Staff Report

MINOR MODIFICATION

June 2, 2009 Planning & Zoning Commission meeting

Report date: May 29, 2009
Project type: Exterior Modifications
Legal description: Lot 20, Block 2, Benchmark at Beaver Creek Subdivision
Zoning: TC – Town Center
Address: 48 E. Beaver Creek Boulevard

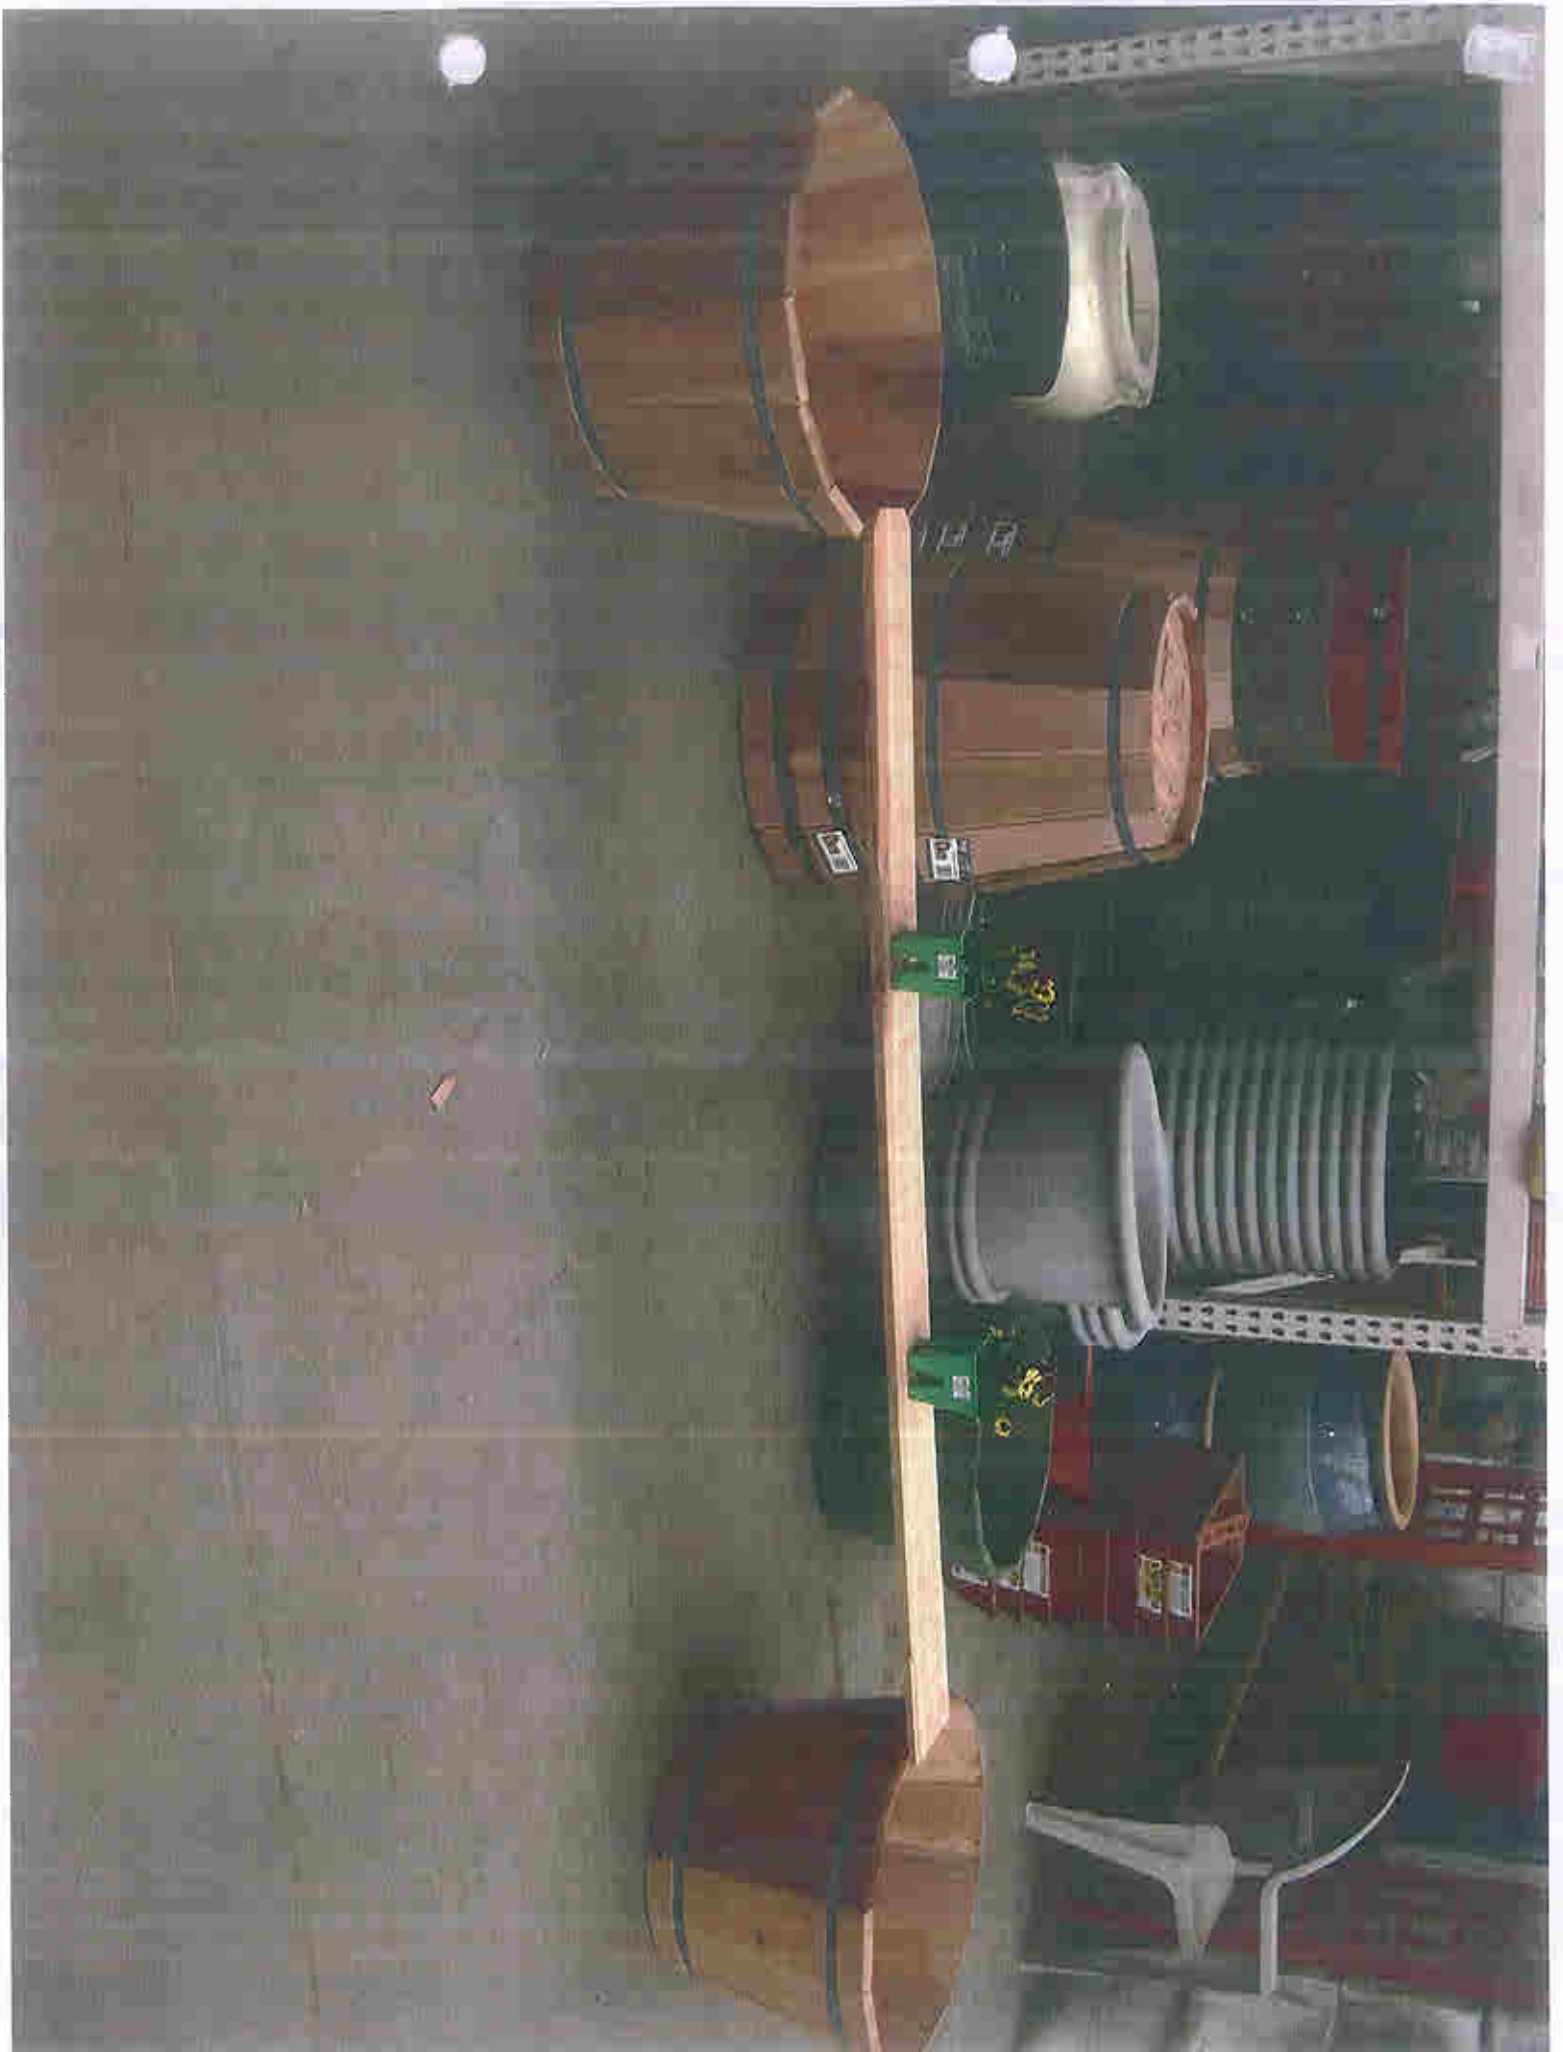
Given the limited height of the proposed cedar planters (2') and planks, Staff has concerns over the visibility and stability of the proposed improvements. Staff is recommending the Commission table this application in order to allow the applicant to revise their proposal to incorporate Staff's concerns as stated above.

- *Building Materials and Colors:* The proposed materials, as stated earlier in this report, are two foot (2') square by two feet (2') tall planters and eight foot (8') long planks. Both of the materials will be made of cedar and will remain in a natural state. As proposed, the materials do not appear to complement the outdoor seating area in front of Vin48 and are visually incompatible with the existing building. As stated earlier in this report, Staff has concerns about the visibility and stability of the proposed improvements.
- *Exterior Walls, Roofs, and Architectural Interest:* As proposed, the wall colors and materials should be compatible with the site and the surrounding buildings. The architectural character of the proposed modification meets the requirements of the Design Guidelines and is compatible with the surrounding neighborhood.

- 1. The applicant must revise the application to provide more of a vertical/visible presence and physical stability to the method of delineation for the outdoor seating area and liquor license boundary prior to approval; and,*
- 2. Prior to approval, the applicant must provide a scaled site plan that shows all site improvements as well as easements and setbacks to ensure that there is ample pedestrian circulation through the site and that the proposed improvements do not encroach into any setback or easements.*
